VALUE ENGINEERING WORKSHOP

BUFORD HIGHWAY AND PLEASANT HILL ROAD

Gwinnett County, Georgia

19 August 2004

TYPICAL SECTION
RW-3.0

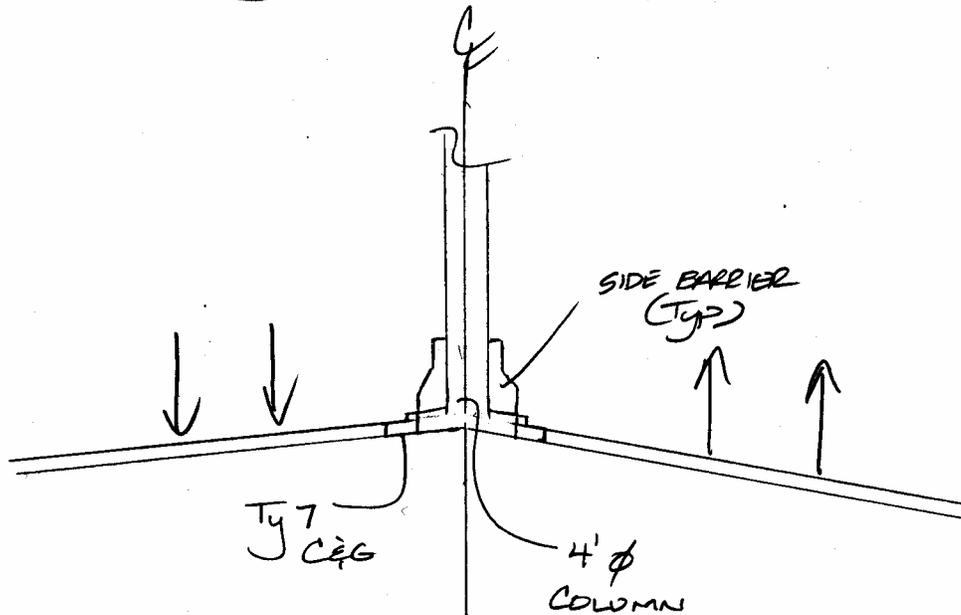
PROPOSAL DESCRIPTION: NARROW PROPOSED MEDIAN ON PLEASANT HILL ROAD FROM 20' TO 12'

ORIGINAL DESIGN: The original design has a Typical Section for Pleasant Hill Road that includes a 20' raised concrete median.

PROPOSED CHANGE: The proposed change would taper the concrete median from Station 124+23 to Station 140+35. The concrete median can be tapered down from 20' to 12' wide in this area. This would include enough width for the 4' bridge columns, Type 7 curb and gutter, and concrete side barriers to protect the columns.

$$\begin{aligned} \text{MEDIAN} &= 4' \phi + 2'-6'' + 2'-6'' \times 2 \\ &= 11'-6'' \text{ MIN} \end{aligned}$$

$$\text{USE} = 12'-0''$$

RW-3.1

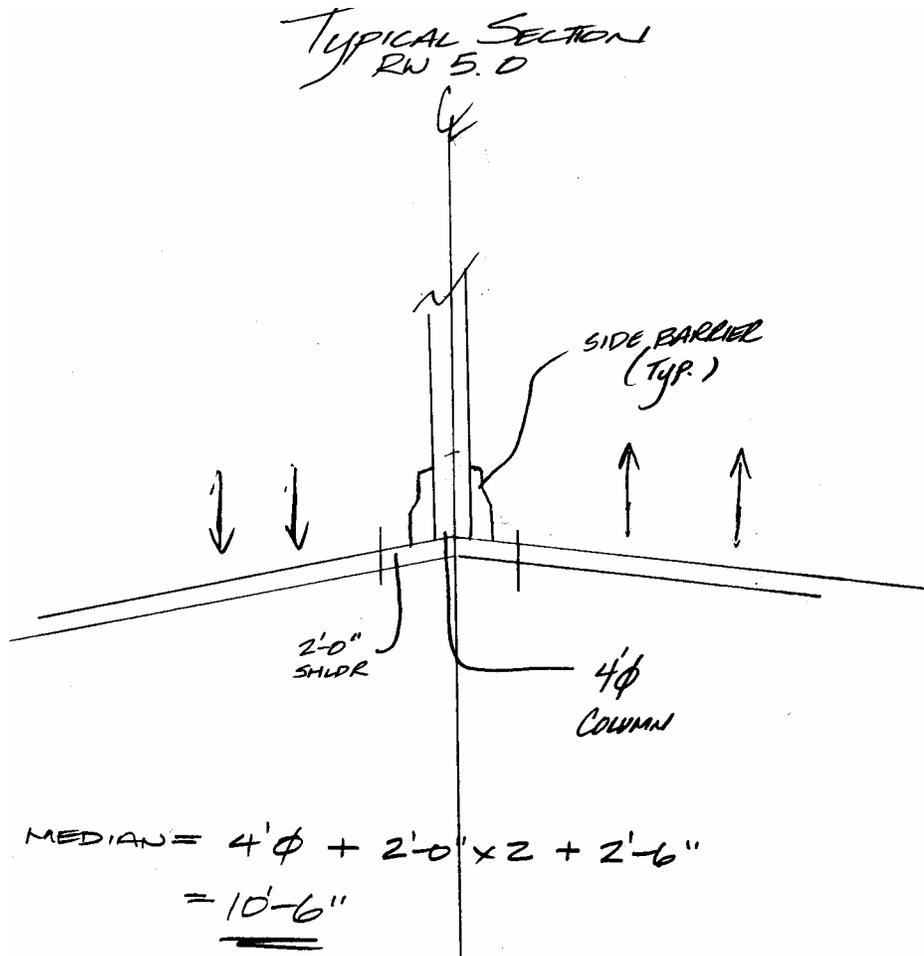
PROPOSAL DESCRIPTION: NARROW PROPOSED MEDIAN ON PLEASANT HILL ROAD FROM 20' TO 10.5' BY USING MEDIAN BARRIER.

ORIGINAL DESIGN: The original design has a Typical Section for Pleasant Hill Road that includes a 20' raised concrete median.

PROPOSED CHANGE: The proposed change would taper the concrete median from Station 124+23 to Station 140+35. The concrete median can be tapered down from 20' to 10.5' wide in this area. This would include enough width for the 4' bridge columns, side barriers, and 2' inside shoulders.

PROPOSAL NUMBER:	RW-4.0
PAGE NUMBER:	4 of 5

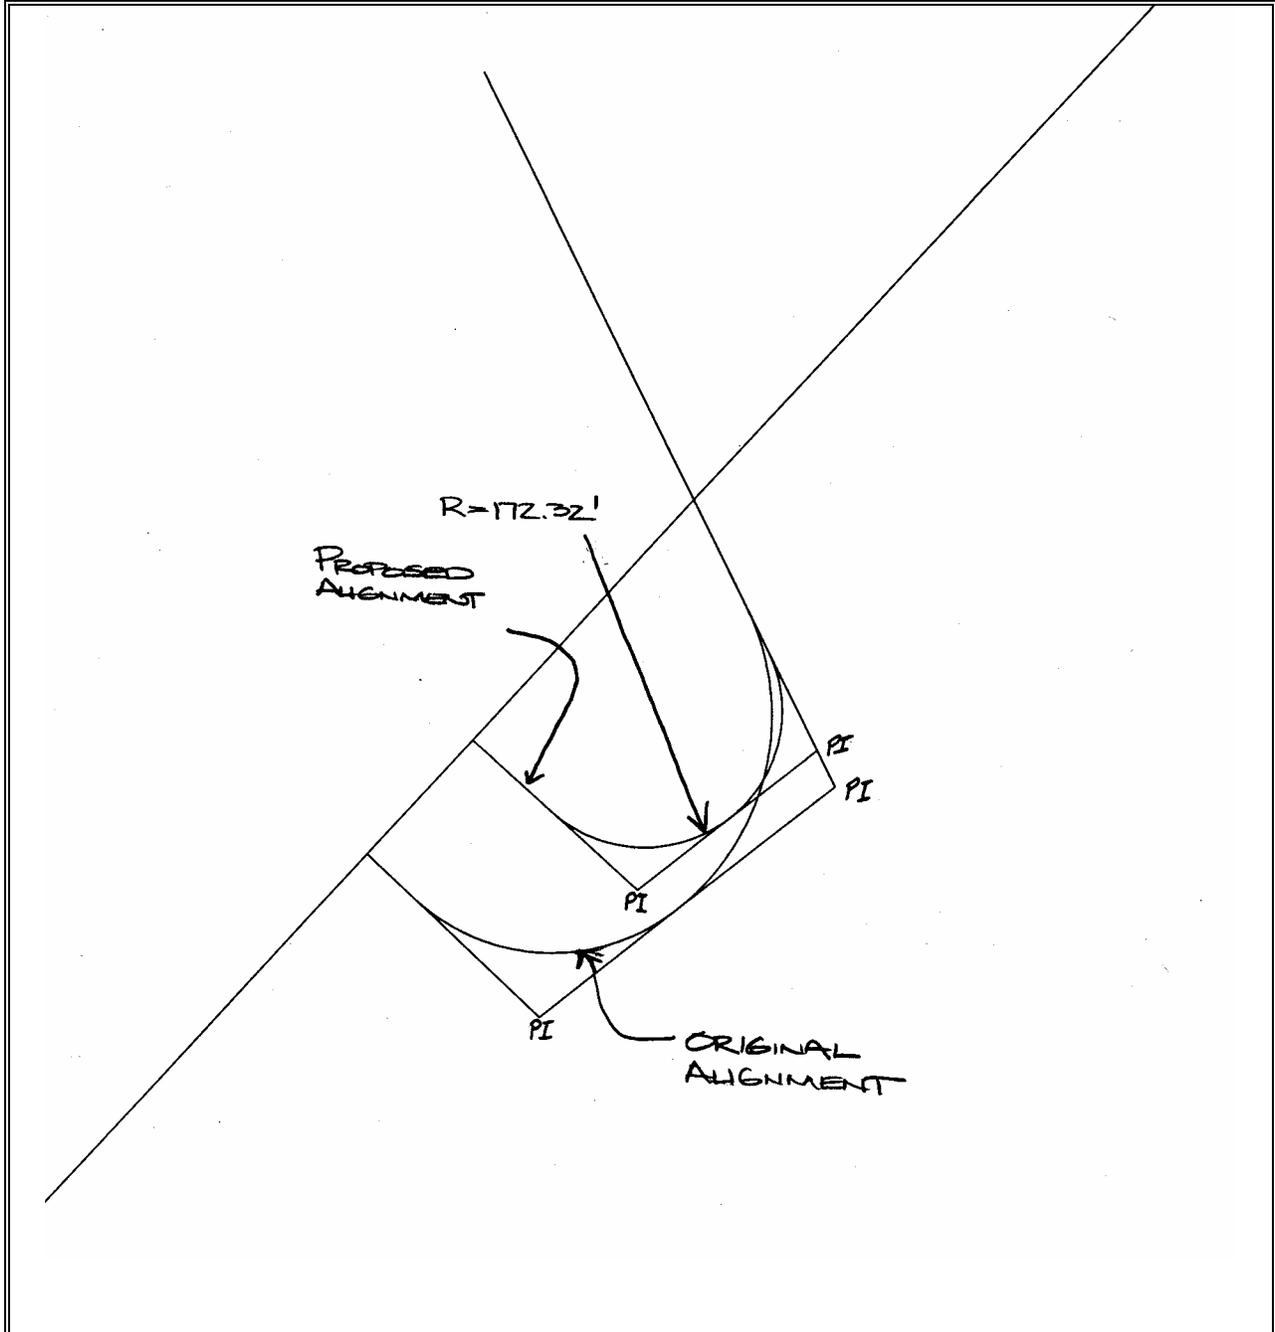
PROPOSAL DESCRIPTION: REVISE DESIGN OF RAMPS A/B TO MORE CLOSELY MATCH RAMPS C/D.

ORIGINAL DESIGN: The original Ramps A and B use horizontal curves approx. 312' and 252' Radii, and tie in with Buford Highway at approximately. Sta. 210+54.57.

PROPOSED CHANGE: The proposed recommendation is to redesign Ramps A and B to use radii similar to Ramps C/D, approx. 172' Radius, and will tie in with Buford Highway 200' NE of current design.

PROPOSAL NUMBER:	RW-6.0
PAGE NUMBER:	4 of 5

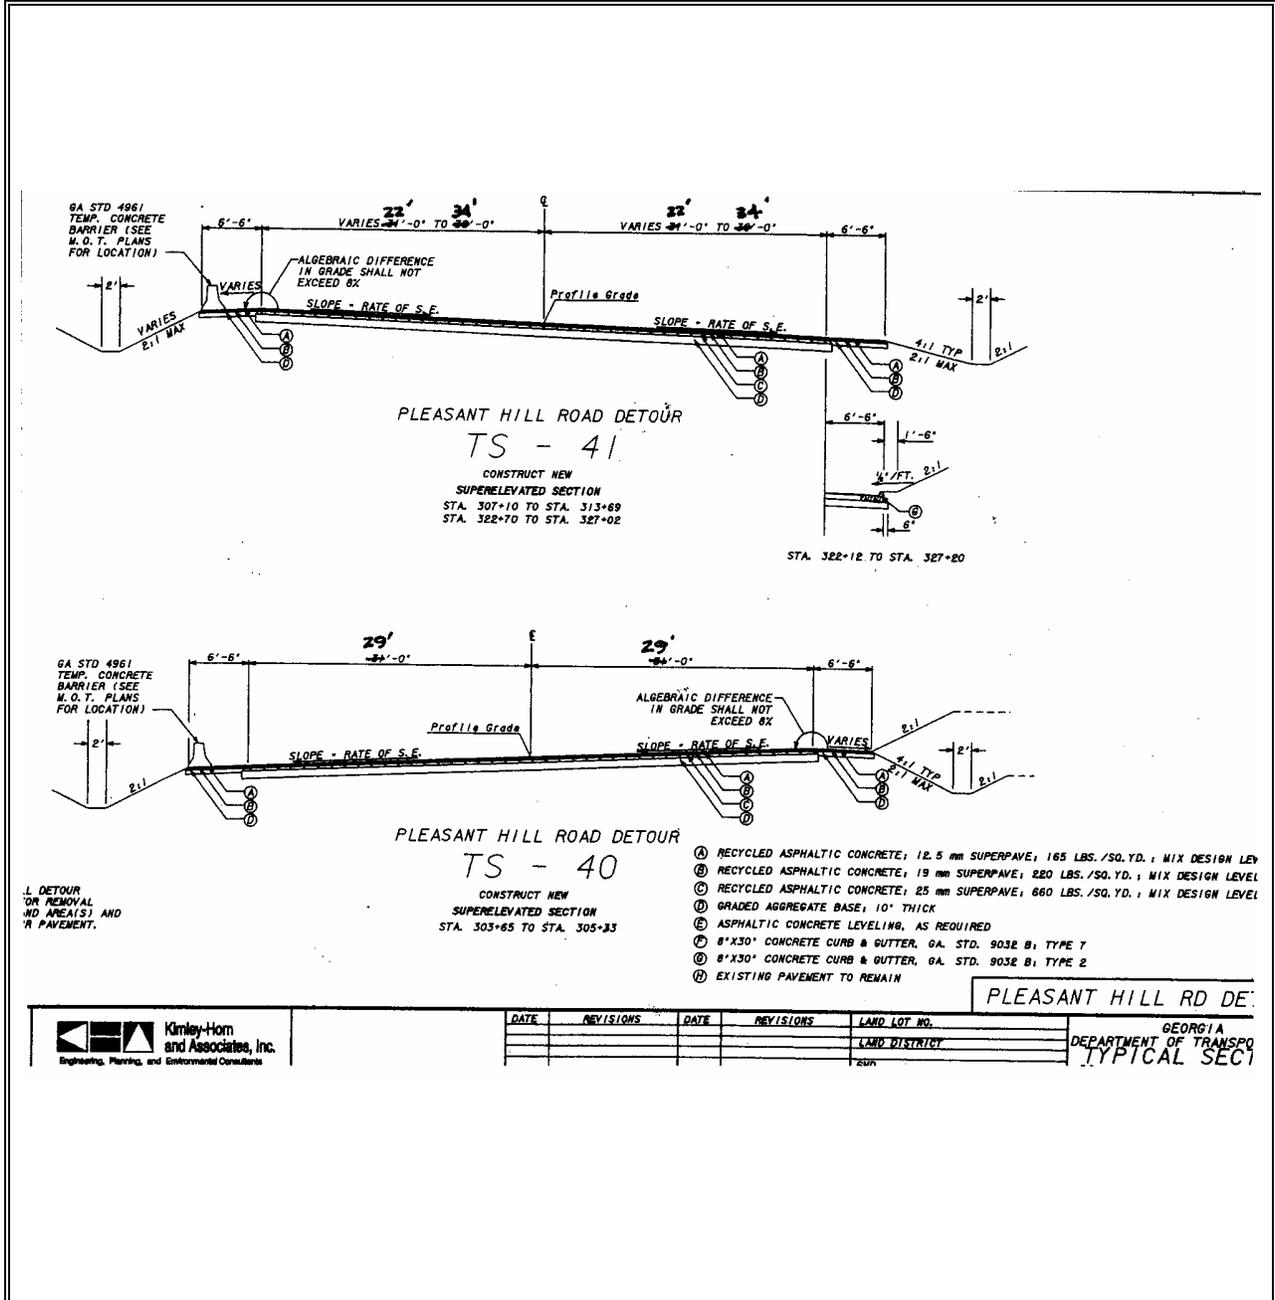
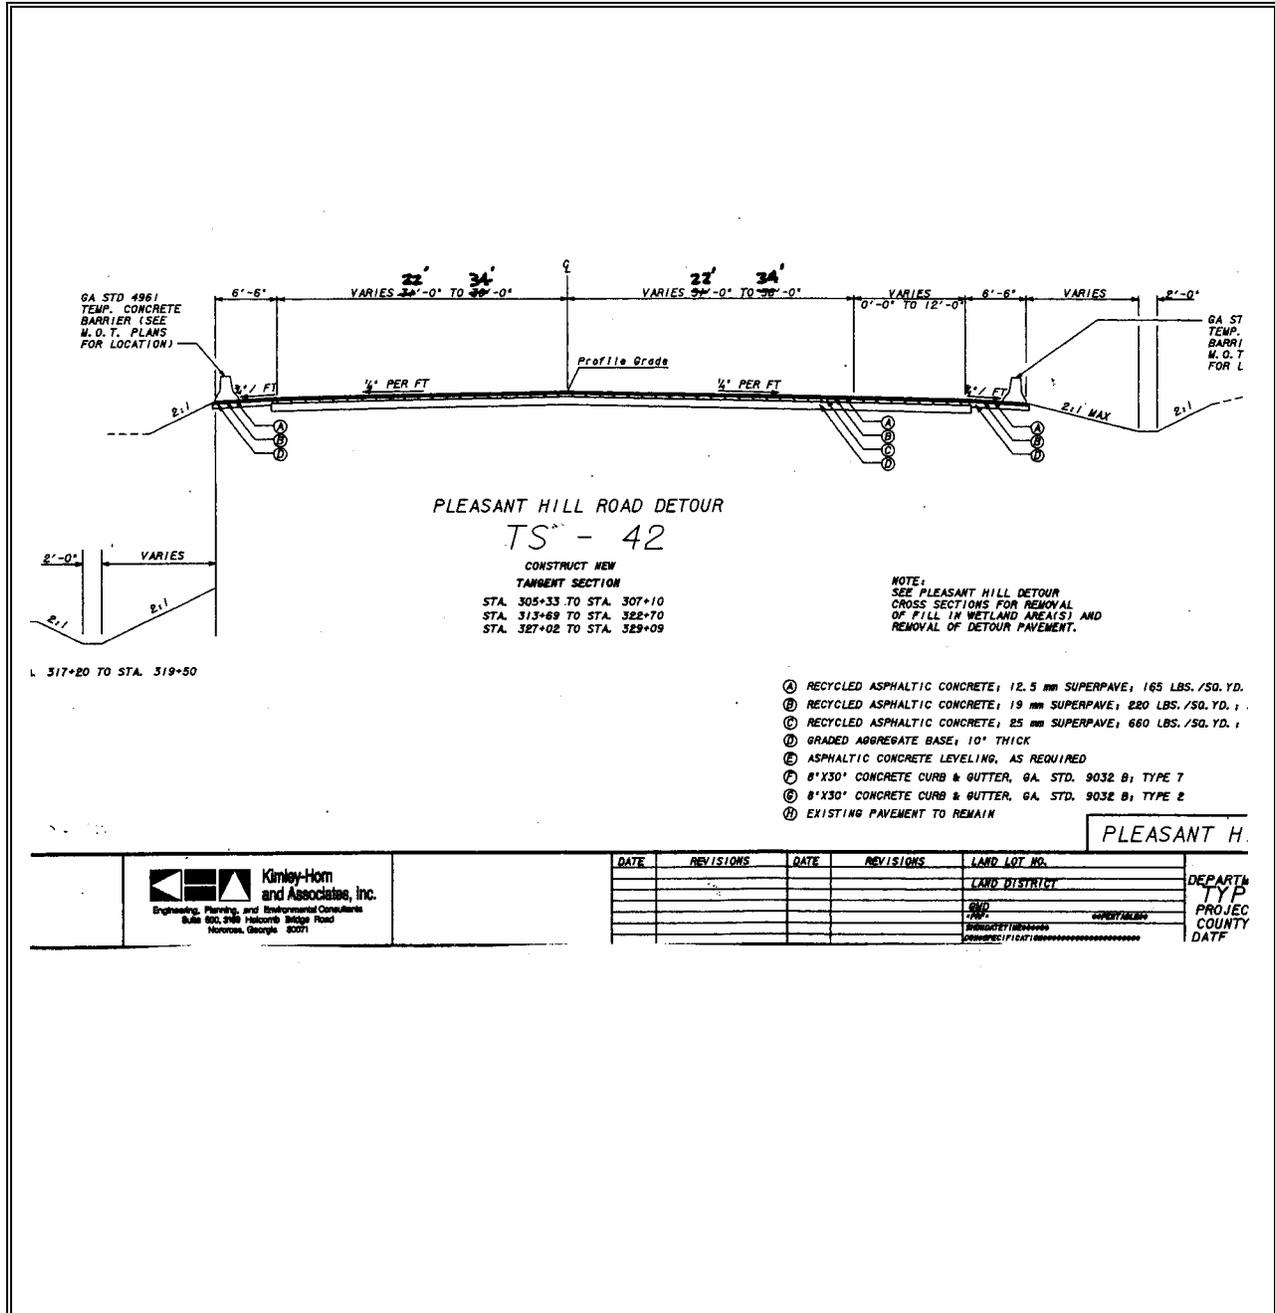
PROPOSAL DESCRIPTION: DELETE THE HATCHED MEDIAN ON THE PLEASANT HILL ROAD DETOUR, AND USE 11' TRAVEL LANES.

PROPOSED CHANGE: The proposed change would eliminate the hatched median between station 309+60 and 314+80 as well as reduce the lane width by one foot between stations 305+80 332+00.

LAYOUT OUT OF FINAL RE-ALIGNMENT ALSO

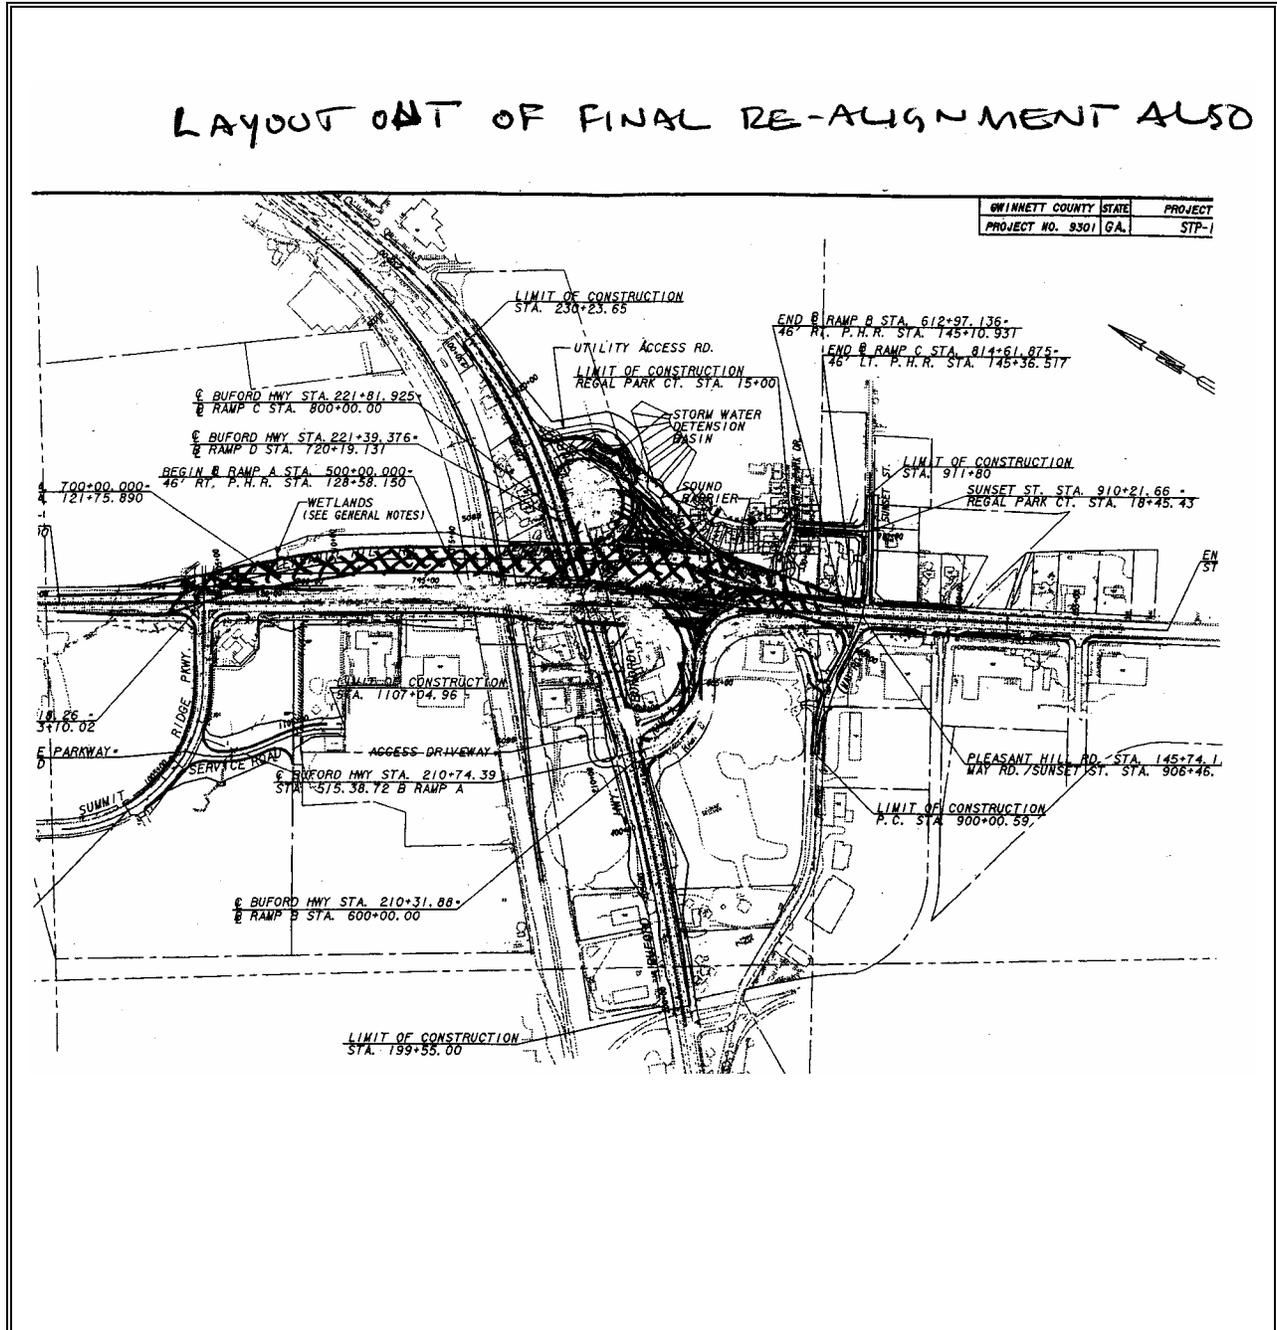
PROPOSED CHANGE: The proposed change would use the proposed detour alignment for Pleasant Hill Road as the final alignment, allowing for the majority of construction to be done with the least amount of disruption to traffic. There will be minimal disruptions during construction and a much faster re-routing of traffic onto new road.

PROPOSAL NUMBER:	RW-9.0
PAGE NUMBER:	4 of 5

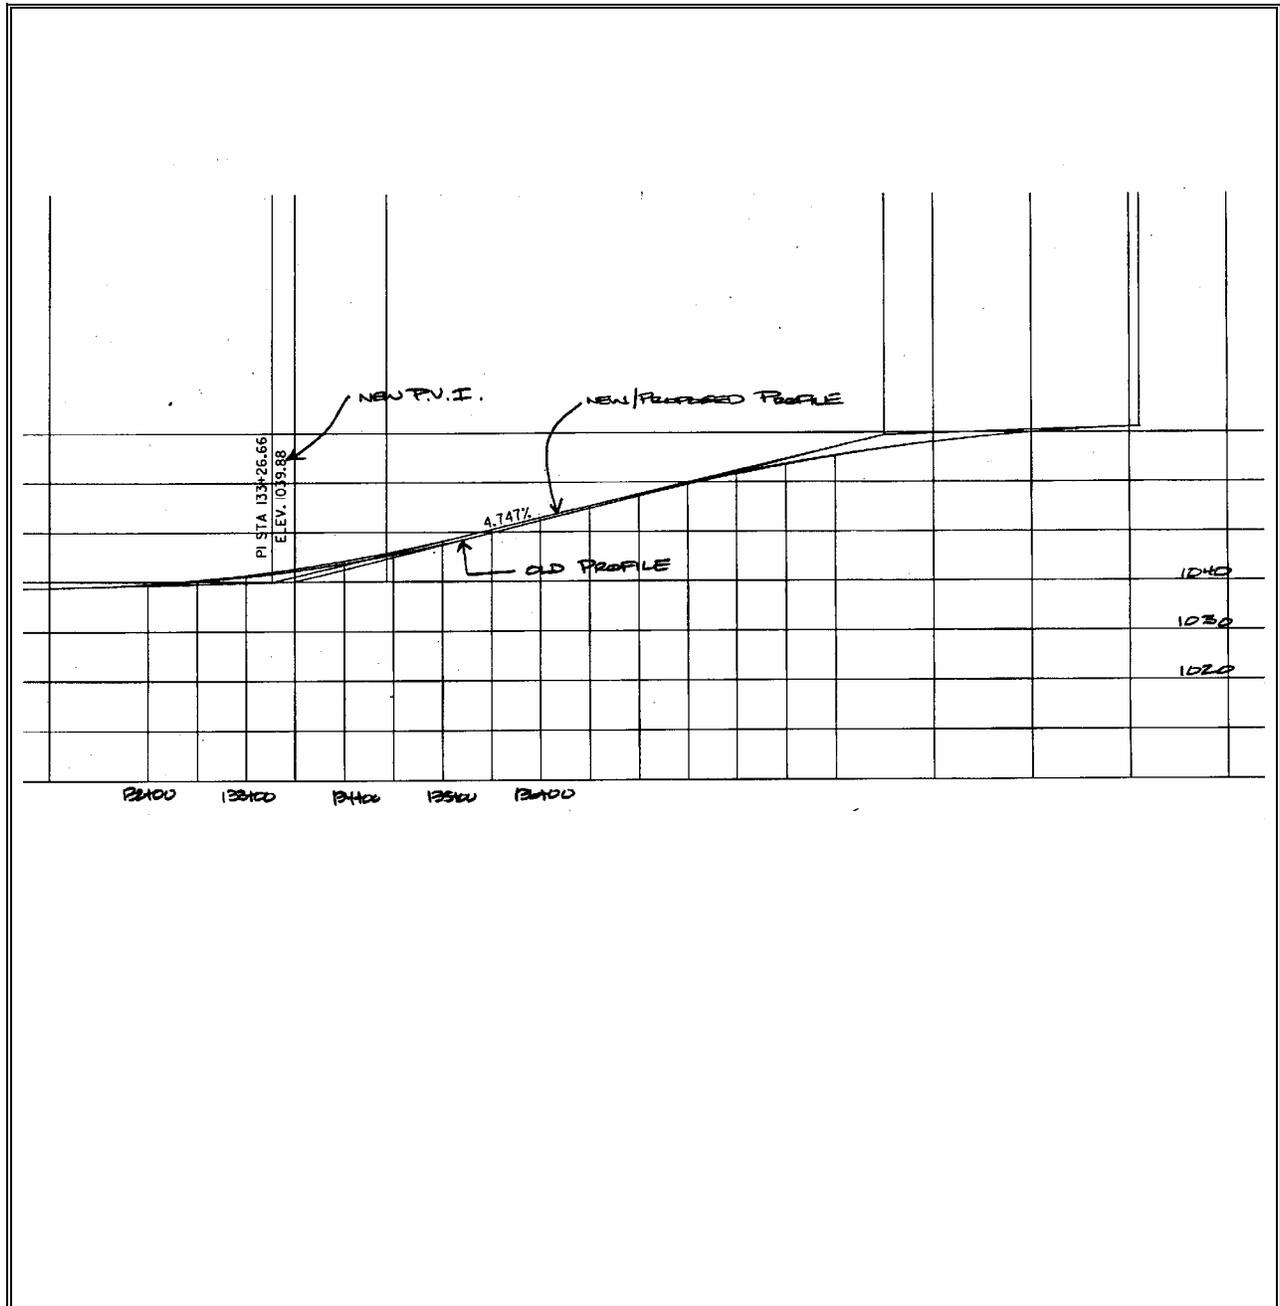
PROPOSED CHANGE: The proposed recommendation is for the profile to be raised in order to make a minimum clearance of 17'-0" underneath the Buford Highway bridge. (Reduction of 11').

Minimizing clearances over/under proposed bridges is good engineering practice. Savings are minimal, and might not be justified compared to the re-design costs involved in changing plans that are 90% complete.
